LiDAR Quality Assessment Report

AK Juneau 1 meter Lidar

This Juneau, AK Quality Assurance report is for planning, acquisition, processing, and derivative products of lidar data for a high resolution data set of approximately 190 square miles, in the city and borough of Alaska.

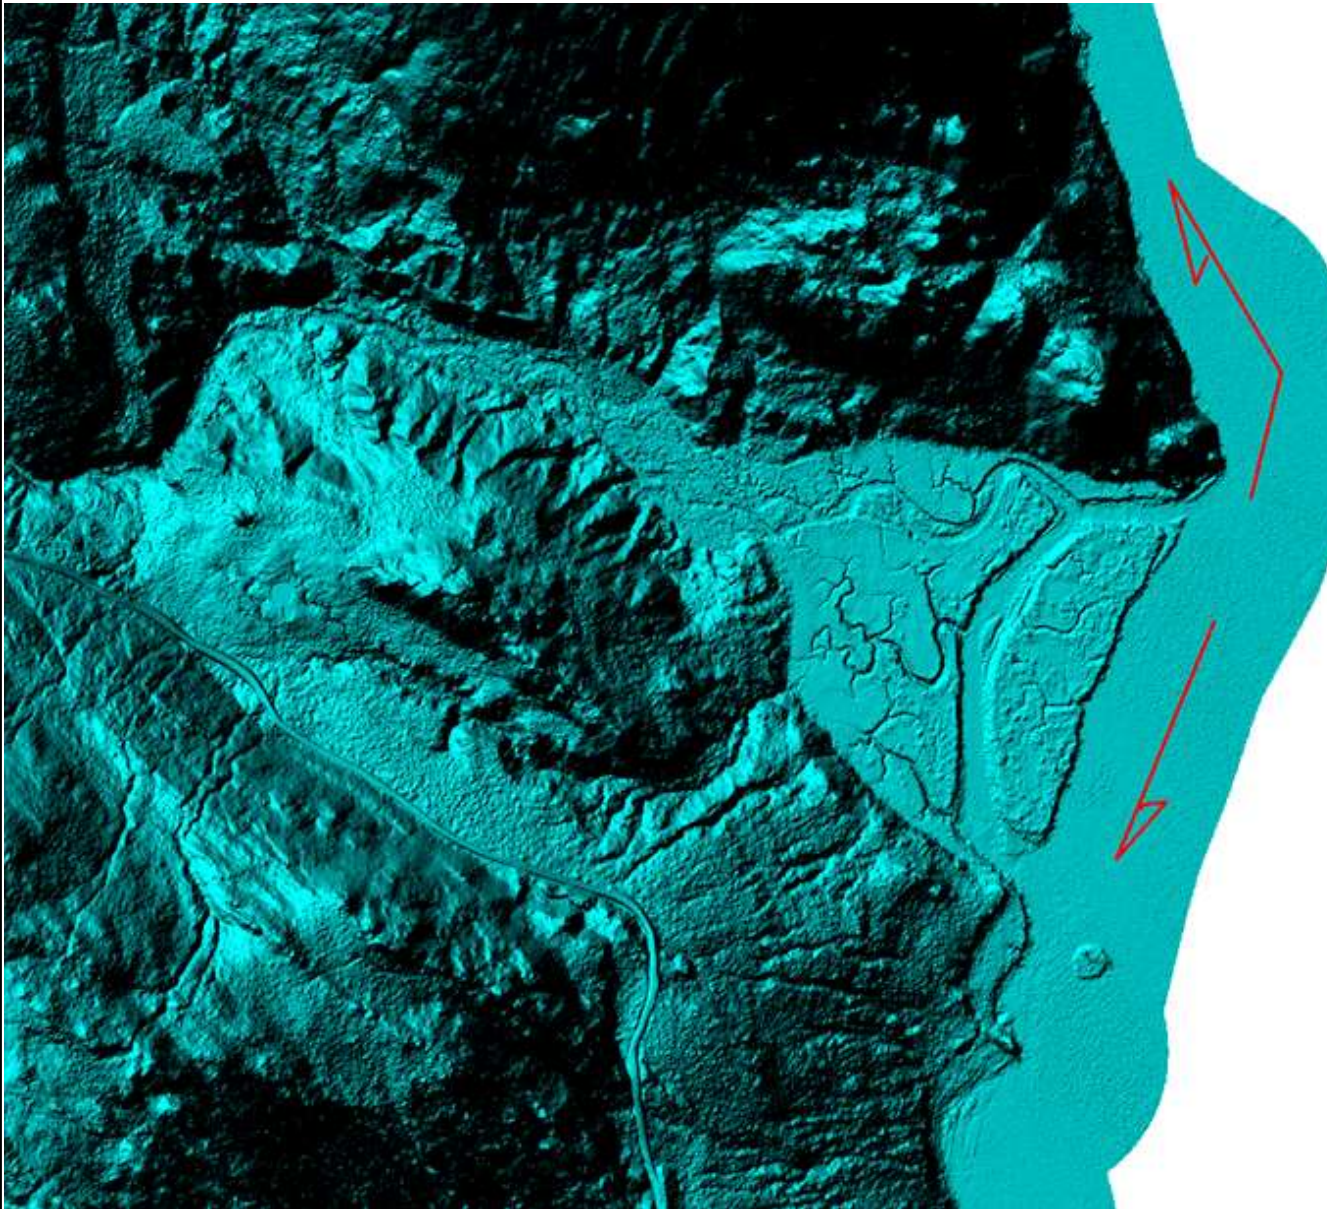
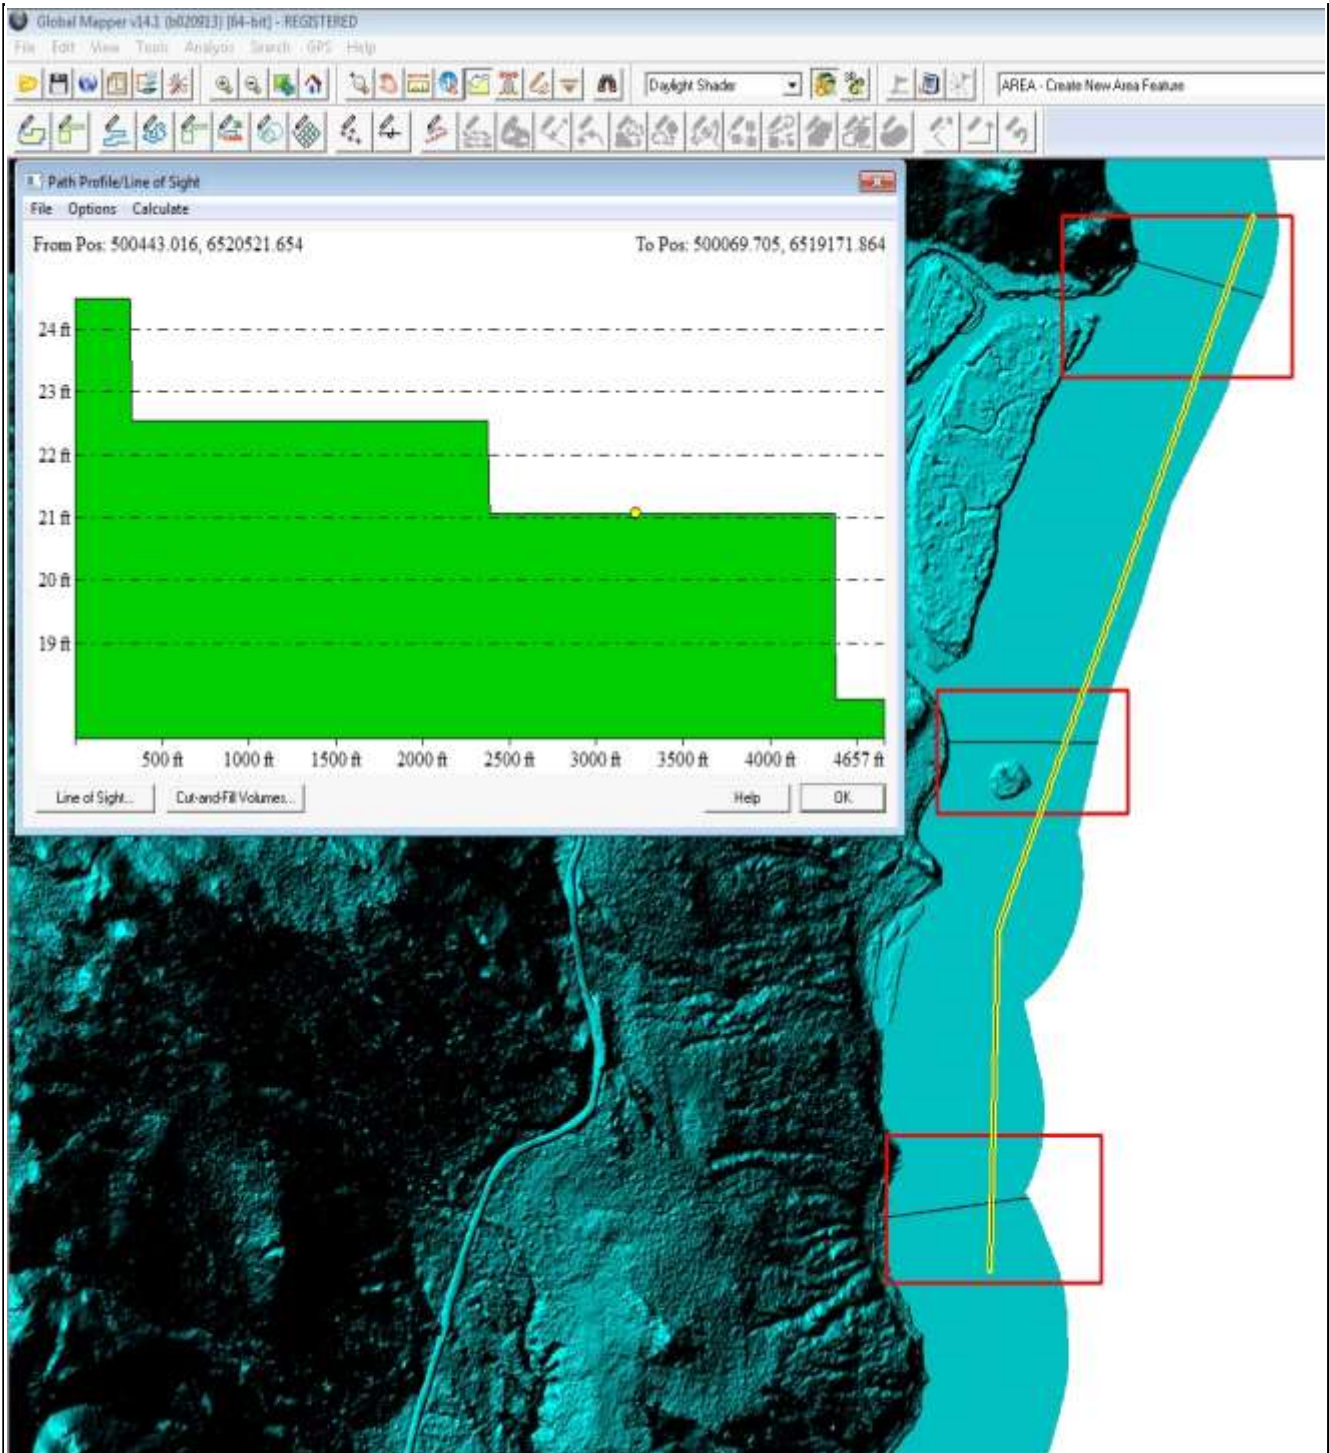
Tidal zone needs hydroflattening at 58° 49' 17.3383" N, 134° 59' 45.1588" W. This Issue is found throughout the dataset, and these images are only representative samples.

****Area hydroflattened for redelivery, however area has stair-step features in elevation profile. Review of this area's swath shows that this area was flown on the same day, but unknown what time of day. Thus, it can not be determined if this is a result of tidal influences or just a hydroflattening artifact. See second image below.****

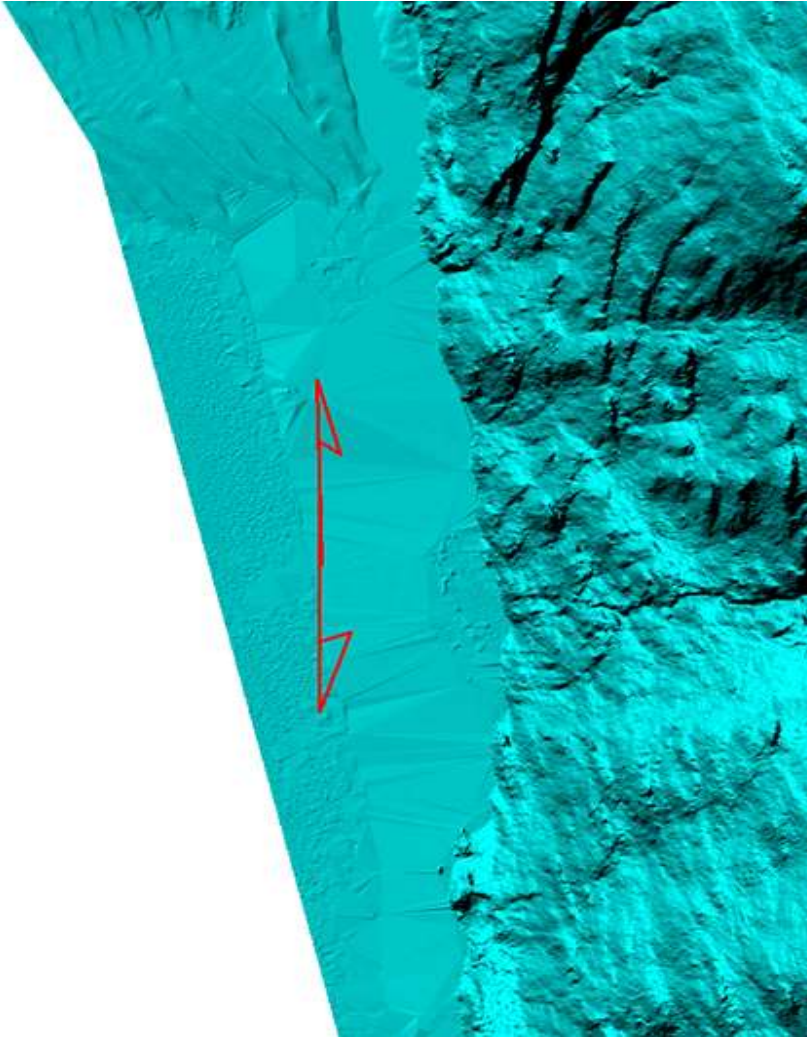
****Area hydroflattened for redelivery, however area shows ~ 5.5 ft drop from land to water in elevation profile. See second image below.****

Tidal zone at 58° 46' 19.1587" N, 134° 55' 53.7303" W

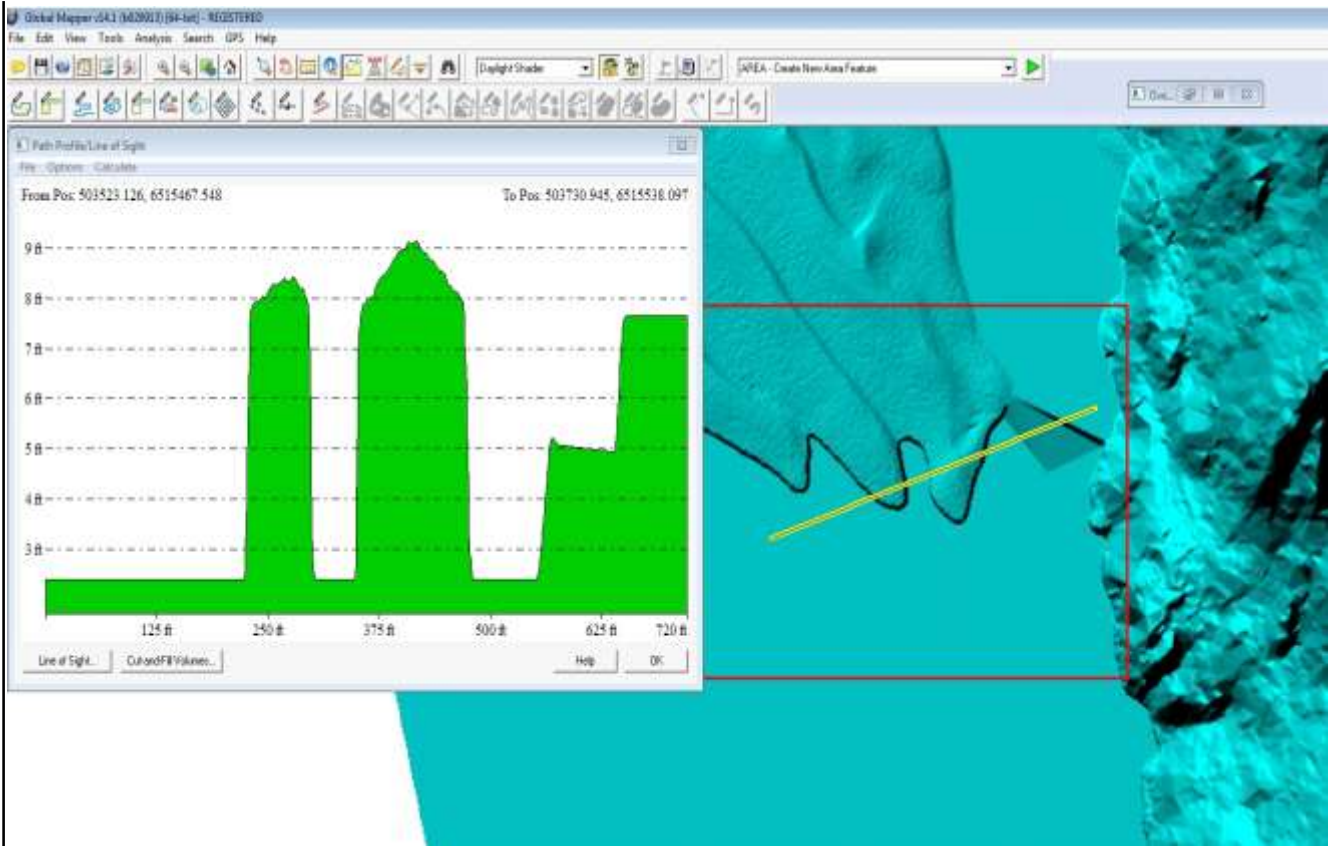
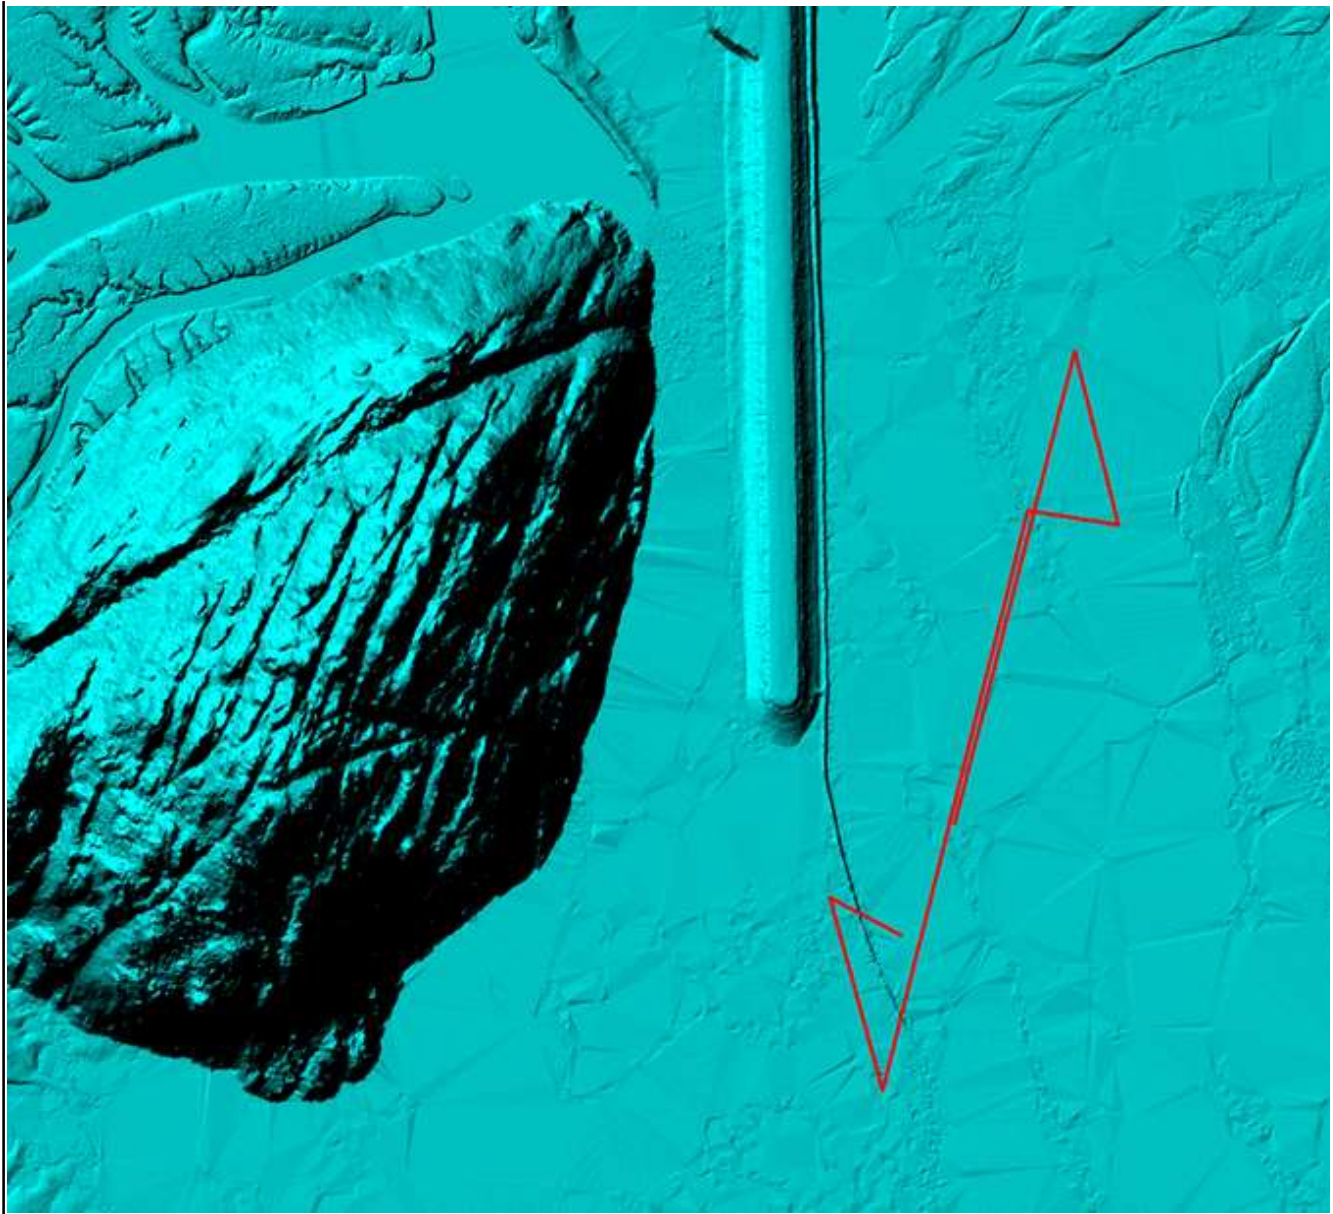
Elevation profile showing drastic drops from land to water in hydroflattened tidal area.

**** Issue was fixed by contractor ****
